Comment Letter #41

Tesoro Refining & Marketing Company LLC

**Re: Comments on SCAQMD 2022 Draft Air Quality Management Plan
Proposed Measure L-CMB-07: Emission Reductions from Petroleum Refineries**

**Re: Second Set of Comments on SCAQMD Revised Draft of Proposed Rule 1109.1 – Emissions of Oxides of Nitrogen from Petroleum Refineries and Related Industries
(Release Date: December 24, 2020)**

Figure 1: Average and incremental cost-effectiveness analysis for Examples 1 and 2

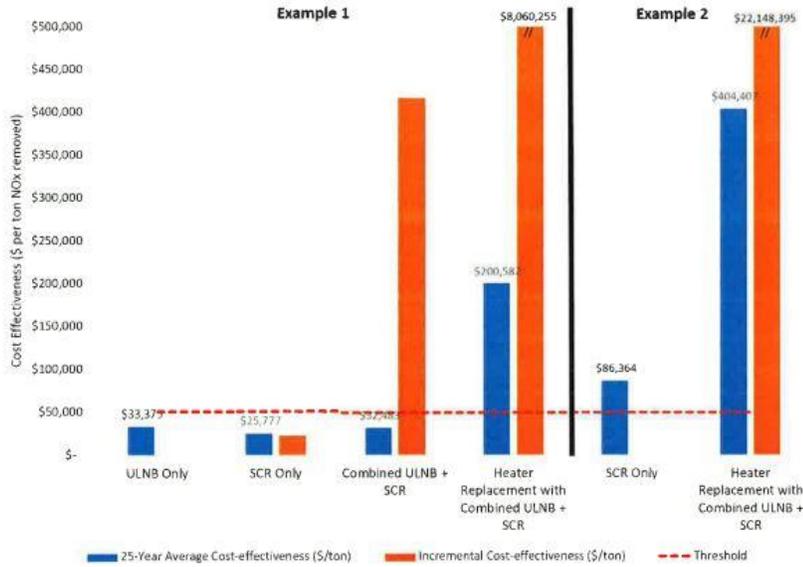
For Example 2, the average and incremental cost-effectiveness values show that both the SCR retrofit and the heater replacement control technology options are significantly above the threshold and thus economically infeasible.

Figure 1 displays the cost-effectiveness results for Examples 1 and 2 relative to the \$50,000 per ton cost-effectiveness threshold established by the SCAQMD Governing Board in the 2016 Air Quality Management Plan and to the relative control technology options on an incremental basis.⁸

Figure 1-8 CFD model of horizontal fired cabin heater.

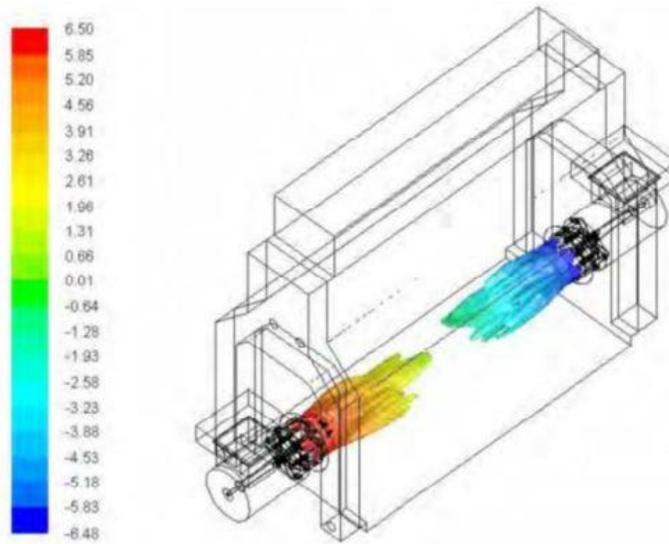
This example shows some space between the flame tips; however, some existing process heater designs may not have this space when ULNBs are installed. If adequate burner-to-burner spacing does not exist, then the flames will interact with either other, spread outward, and impinge on the tubes. Even with enough flame tip spacing between the burners, the radiant section internal currents may pull the flames into the radiant section tubes.

Figure 1-9 Burner firing towards a target wall.

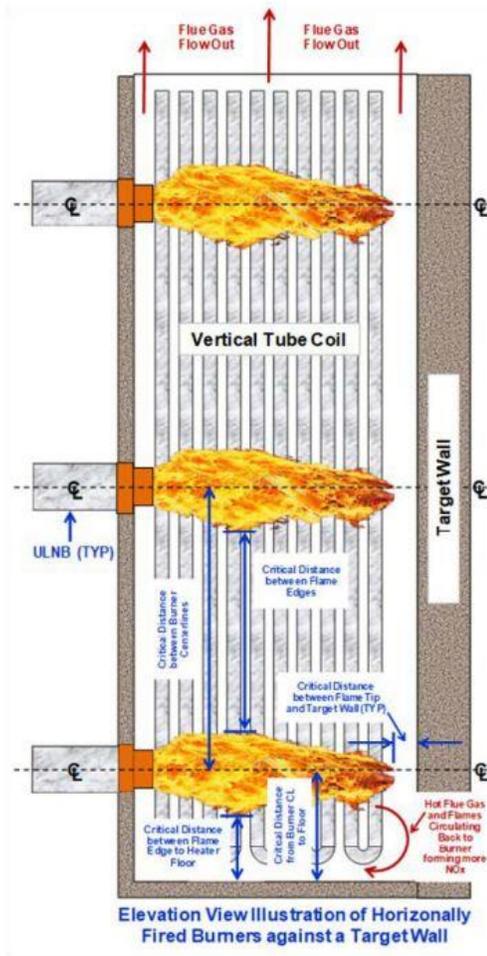
Installing ULNBs with long flames may hit the target wall, spread out, impinge on the tubes, and create additional NOx by hot flue gas and flames near the floor circulating back to the burner. Also, if the flame envelopes are too close to each other, they may spread out and impinge on the process tubes. These consideration must thoroughly be evaluated against the API and company-specific design standards before installing ULNBs at an existing heater.

Figure 2-2 Illustration of flame impingement on process heater tubes.

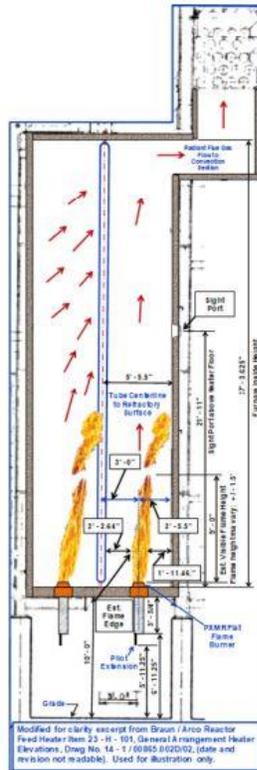
In this design, the heater is a natural draft, double fired box heater with a vertical coil. The convection section is offset from the center of the box requiring the radiant section flue gas to go through the radiant tubes and to the convection section. Installing ULNBs with long flames could result in flame impingement, as shown. Further, long flames with certain heater geometries can cause flame impingement on the radiant arch (roof) refractory, the radiant roof tubes, or the convection shock tubes.

Such flame impingement, as described earlier in this document, could result in catastrophic failure. Therefore, flame impingement on the interior components of the heater must be avoided.

Figure 2-3 Burner firing towards a target wall.

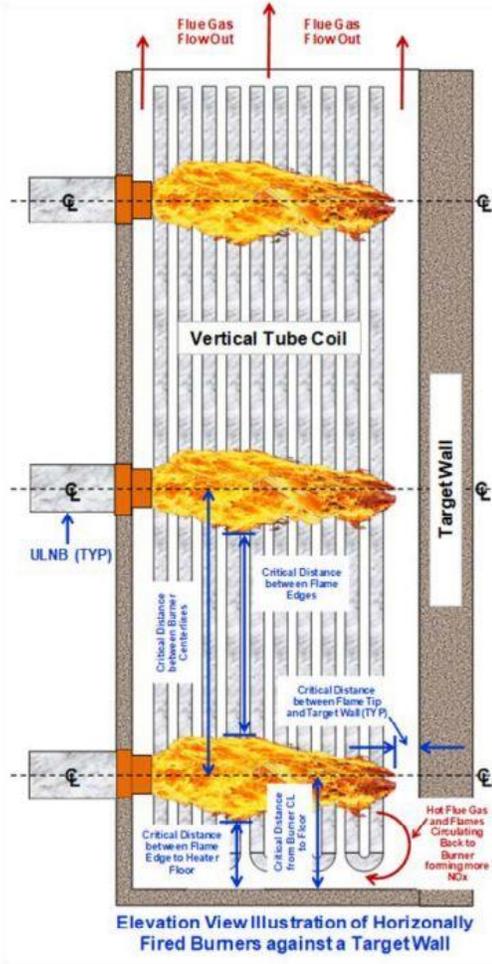
Installing ULNBs with long flames may impact the target wall, spread out, impinge upon the tubes, and create additional NOx by hot flue gas and flames near the floor circulating back to the burner.

Figure 2-4 CFD model of horizontal fired cabin heater.

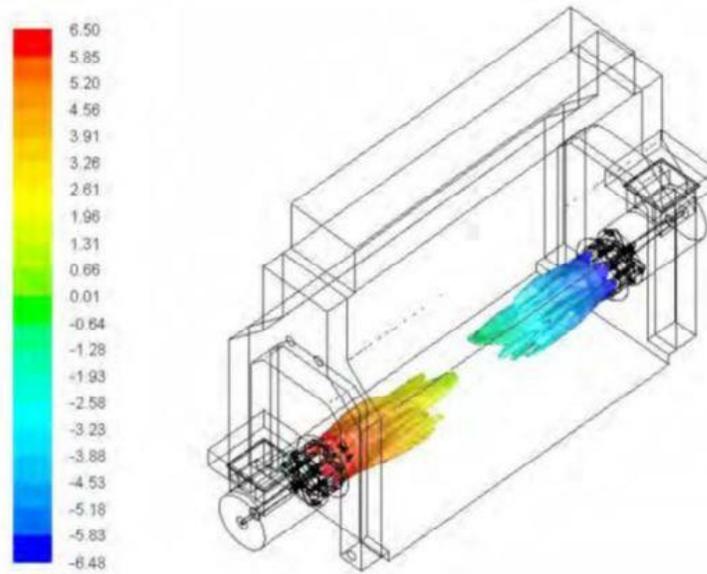
This example shows some space between the flame tips; however, some existing process heater designs may not have this spacing when ULNBs are retrofitted. If adequate space does not exist, then the flames will interact with either other, spread outward, and impinge on the tubes. Even with enough flame tip spacing between the burners, the radiant section internal currents may still pull the flames into the radiant section tubes.
